Replacement Notes for : Fyrnetic, Double

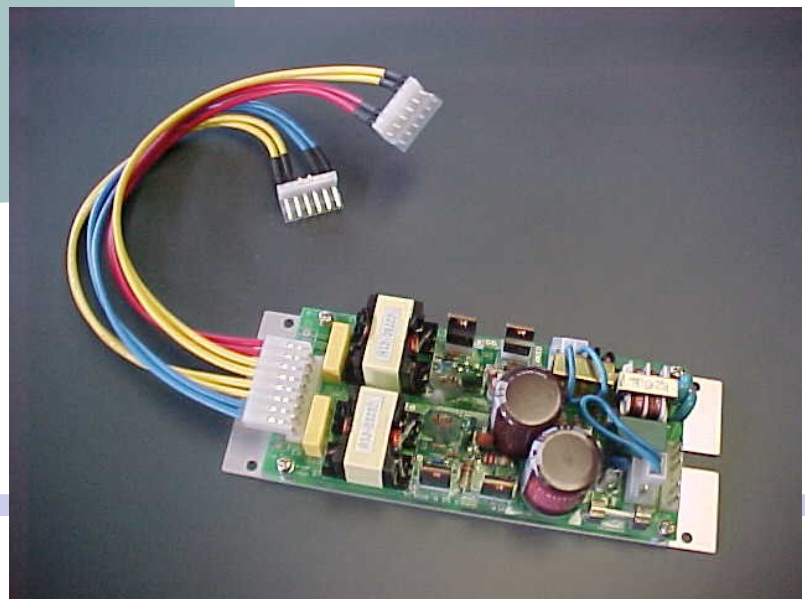
The double Fyrnetic ballast, pictured at left, is replaced by the FA100 ballast using the existing input harness from the tanning unit and adapter harness 8-12OUT-F for the output, as pictured below. Note that only one of the two existing input harnesses from the tanning unit will be necessary to power the FA100.
